Application Number: LU/17766 (TP919/2024)

APPLICATION FOR REZONING TO SUBDIVISIONAL AREA & SUBDIVISION: FARM NO. 1307/2 AND FARM NO. 1307/3 (TO BE CONSOLIDATED), STELLENBOSCH DIVISION

**APPLICATION FOR THE AMENDMENT OF AN
APPROVED SUBDIVISIONAL PLAN AND SITE
DEVELOPMENT PLAN: FARM NO. 1307/2 AND FARM
NO. 1307/3, STELLENBOSCH DIVISION**

**COMMENT FROM THE DIRECTORATE:
INFRASTRUCTURE SERVICES**

Figure 2: Extract of the approved Subdivision Plan

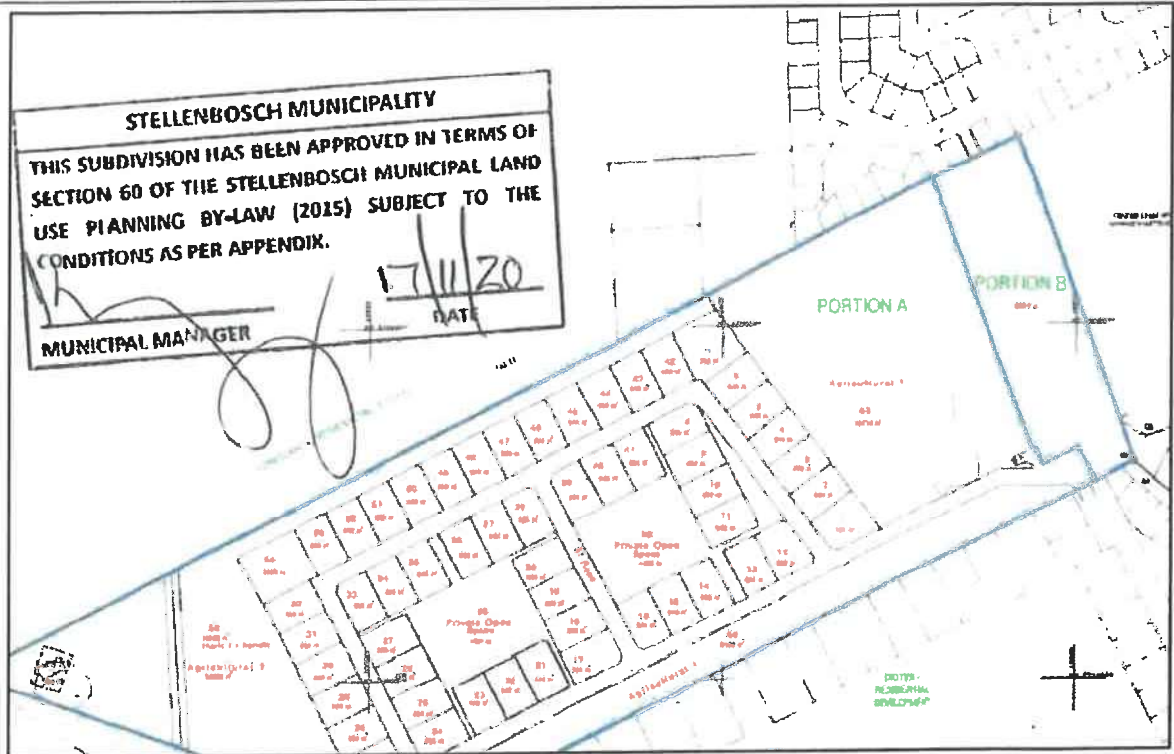
5.1 *The MPT wishes to know what is going to happen to portion 121 – see image below of the proposed subdivision plan.*

In the short term, portion 121 will retain its current agriculture zoning and use as approved by the Stellenbosch Municipality on 17 November 2020 – see image below of the approved subdivision plan.

This application proposes no changes for portion 121. However, in the future, the applicant may investigate the possible development of portion 121 as an extension to Longlands Life. If it is a viable development option, then the applicant will submit the necessary land use planning applications to the Stellenbosch Municipality for assessment and a decision.
